Response to the Reviewers' Comments

The authors would like to thank the reviewers for the precious comments and suggestions on the technical contents and presentation of our manuscript "Runtime Power Management of Battery Electric Vehicles for Extended Range with Consideration of Driving Time," submitted to IEEE Transactions on Very Large Scale Integration (TVLSI.) This revised manuscript has been greatly improved thanks to the reviewers' invaluable advices. We have revised the manuscript faithfully following the reviewers's comments. We include the newly added or significantly modified parts in the revised version of the paper also in Response to Reviewers. We highlight the important technical content changes and set those parts in a red color in the revised paper.

Fig. 1: (a) Range-speed experimental data for Chevrolet Bolt [36] and (b) comparison with simulation results of the proposed EV power model.

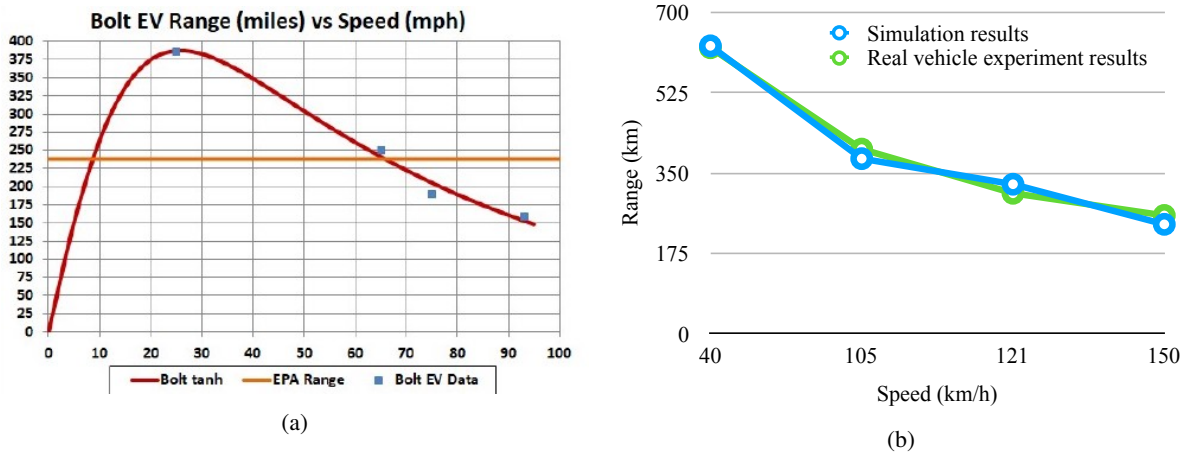
R1-C2 It is not clear how to validate the power model of EV. As the author mentions that accuracy of power model is quite important, it is good to see the power model in this paper can be validated by some real measurement results.

R2-C1 The paper claims that the proposed BEV power model is more accurate than those in the literature. While the results in Section V demonstrate the benefits of the proposed model and in some way indirectly show its accuracy, it would be good to have a direct comparison of model accuracy between the proposed model and those in literature, e.g., based on simulations as in Fig. 1.

In this paper, we use the same EV power model equation in [1], which has been proven to be accurate as long as the coefficients are appropriate. However, the model coefficients in [1] are only for low-speed, ultra light-weighted EV (a half metric Ton). However, we would like to demonstrate a more practical results that are applicable to production EVs. Therefore, all the coefficients should be updated for production-scale EVs in this paper.

Here goes how we extracted correct coefficients of the EV power equation. We use a vehicle simulator that supports EV as well, ADVISOR, to extract the coefficients of new vehicles starting from known vehicle specifications such as the aerodynamic resistance, rolling resistance, curb weight, and so on. Such data is often published in the users' manual, website and so forth. We further use the vehicle performance data such as the top speed, maximum acceleration, and so on, which are also available on the manuals and website. We iteratively run ADVISOR and derive the model coefficients so that all the known values match among each other. We evaluate the model accuracy with the range-speed real vehicle experiments as shown in Fig. 1(a), which has been published by [32], [33], [34], [35], [36]. We further refine the coefficients until all the available data values match well. Finally, the derived EV power model well matches with the range-speed experimental data as shown in Fig. 1(b) as well as the top speed and maximum acceleration, setting the aerodynamic resistance, rolling resistance, curb weight, etc. with the known (fact) values. The errors of the range-speed simulation is merely 1.4%, the time to approach 60 mph at departure is 7.8%, and the top speed is 3.0%, respectively. We revised the manuscript adding the following paragraph with a new figure in Section III-A on page 3 and 4.

We use ADVISOR to extract the model coefficients of new vehicles starting from known vehicle specifications such as the aerodynamic resistance, rolling resistance, curb weight, and so on. Such data is often published in the users' manual, website and so forth. We further use the vehicle performance data such as the top speed, maximum acceleration, and so on, which are also available on the manuals and website. We iteratively run ADVISOR and derive the model coefficients so that all the known values match among each other. We evaluate the model accuracy with the range-speed real vehicle experiments as shown in Fig. 1(a) [32], [33], [34], [35], [36]. We further refine the coefficients until all the available data values match well. Finally, the derived EV power model well matches with the range-speed experimental data as shown in Fig. 1(b) as well as the top speed and maximum acceleration setting the aerodynamic resistance, rolling resistance, curb weight, etc. with the known values. The errors of the range- speed simulation is merely 1.4%, the time to approach 60 mph at departure is 7.8%, and the top speed is 3.0%, respectively. The model coefficient extraction result shows as in Fig. 2. The normalized root-mean-square deviation is 5.1%. Table I summarizes the model coefficients of (5) for Chevrolet Bolt.

Fig. 12: Comparison of *EDP* for various energy-aware-velocity planning methods.

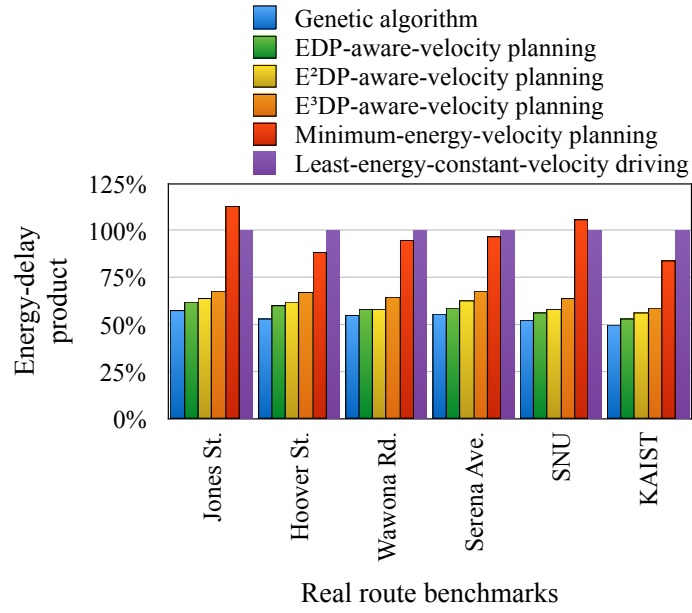
R1-C3 The optimality of the proposed scheduling algorithm is unclear. The author should add several paragraphs to discuss this topic. It is also to see the comparison baseline is well accepted to show the advantage of the proposed algorithm.

Fig. 12 shows EDP of the least-energy-constant-velocity driving, the velocity planning with EDP , E^2DP and E^3DP as a metric on various road benchmarks and the minimum-EDP-velocity planning with GA. The proposed velocity planning results in up to 47% improvements of EDP compared with the least-energy-constant-velocity driving. The improvements occur especially when the slope of the uphill is steep. The driving velocity on a flat road is faster than that of the least-energy-constant-velocity driving at the expense of relatively little energy to save driving time. Then, the velocity decreases when climbing the following uphill to spend less motor torque, which saves more energy.

In addition, the proposed EDP-aware-velocity planning is merely 7.8% higher than the true EDP-minimum-velocity planning on average. Through this results, we confirm that the results of the proposed heuristics are close enough to the true optimal solutions.

Fig. 13: Histogram of (a) velocity and (b) acceleration for various energy-aware-velocity planning methods.

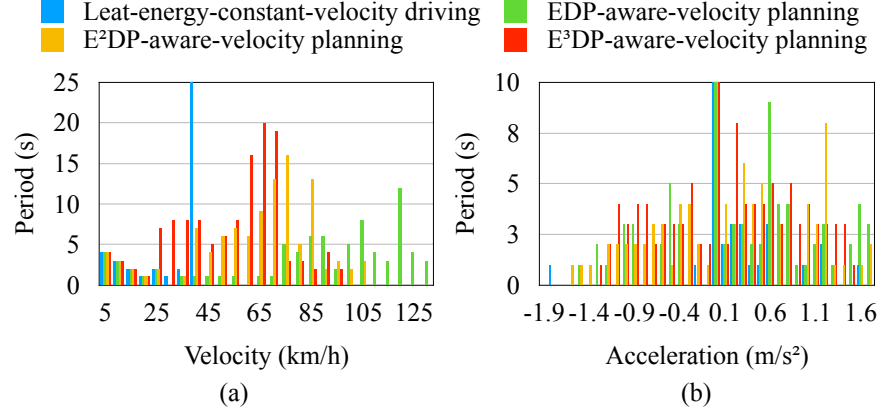
R2-C2 It would be good to have more discussion on the assumptions of the approach and the experiments, e.g., how much can the velocity be changed in practical scenarios without impeding traffic and causing unsafe situations (also depending on the road conditions and whether it is urban or rural environment I suppose). Currently, there only seems to be one constraint on not slower than 10 km/h.

R3-C2 Three different energy-delay product metrics are given in the paper. Can you recommend which one would be the best practical scenarios?

We previously constrained that the EV should not drive too slow to avoid bothering traffic with the minimum speed of a 10 km/h. However, such velocity constraint is not realistic even in a city driving as the reviewer pointed out. We do agree on that more realistic minimum speed constraint is desirable, and thus we revised the constraint from 10 km/h to 25 km/h. Even with the new minimum speed constraint, we exhibit the same amount of gains with the proposed methods. After carefully analyzing the acceleration histogram, in this revised version of the manuscript, we newly enforce the minimum acceleration not lower than 0.4 m/s^2 when the EV starts from a stop sign or a traffic light until the velocity reaches to 25 km/h not too bother traffic flow. If the EV accelerates at a 0.4 m/s^2 , it would take 15 seconds to reach a 25 km/h speed. The previous version of the manuscript used the maximum acceleration limited by the motor torque: a 4.7 m/s^2 on a flat road. However, such a fast acceleration negatively affects to the power consumption as well as passenger comfortness. The revised version of the manuscript limits the maximum acceleration to 1.7 m/s^2 as shown in Fig. 13(b), which is the same as the maximum acceleration of compact cars designed to be primarily used in urban areas (15 seconds of 0 to 100 km/h time.)

We assume that the EV should not drive too slow to avoid bothering traffic with the minimum speed of a 25 km/h. Even with the minimum speed constraint as lower than 25 km/h, we exhibit the same amount of gains with the proposed methods. After carefully analyzing the acceleration histogram, we newly enforce the minimum acceleration not lower than 0.4 m/s^2 when the EV starts from a stop sign or a traffic light until the velocity reaches to 25 km/h not too bother traffic flow. If the EV accelerates at a 0.4 m/s^2 , it would take 15

seconds to reach a 25 km/h speed. The maximum acceleration is limited by the motor torque: a 4.7 m/s^2 on a flat road. However, such a fast acceleration negatively affects to the power consumption as well as passenger comfortness. We limit the maximum acceleration to 1.7 m/s^2 as shown in Fig. 13(b), which is the same as the maximum acceleration of compact cars designed to be used primarily used in urban areas (15 seconds of 0 to 100 km/h time).

We quantize the velocity and acceleration values and make a histogram as shown in Fig. 14 (Please refer R2-A2). For the EDP -aware-velocity planning, it is used when the deadline is the most important concern. Therefore, it is guided to drive at a speed of 75 to 130 km/h mainly regardless of the road slope. On the other hand, the E^2DP - and E^3DP -aware-velocity planning methods are used when the remaining battery state of charge is more concerned than the deadline. It is guided to drive at an energy-efficient speed along a road slope. Particularly, the E^3DP -aware-velocity planning method is used when the state of charge is more concerned, and the driver should find the nearby charging station. It is guided to decelerate to 25-40 km/h when climbing hills to further reduce energy consumption.

Fig. 9: Benchmark altitude.

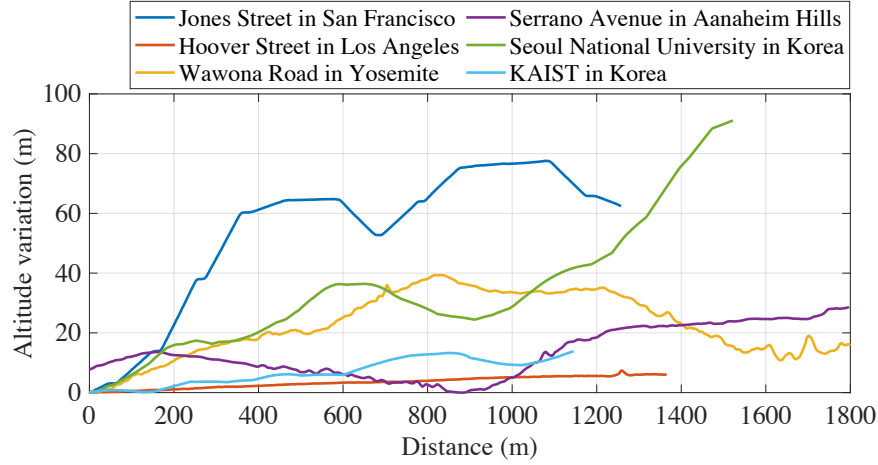
R2-C3 Related to the last point, it would be good to have more discussion on the road benchmarks, e.g., how they are generated and how representative they are. The optimization results significantly depend on road slope. It would be good to use a variety of real road segments for testing.

R2-A3 We appreciate the reviewer’s comment and added six new real routes from various locations in the world. First two routes consists of road segments in cities (San Francisco and Los Angeles, the two representative city landscapes such as hills and flat roads, respectively). The second two routes are road segments in mountain areas (Yosemite and Anaheim Hills in California.) The last two routes are university campus road segments. The details of route data is summarized in Table II and Fig. 9, which visualize the altitudes of the benchmarking routes.
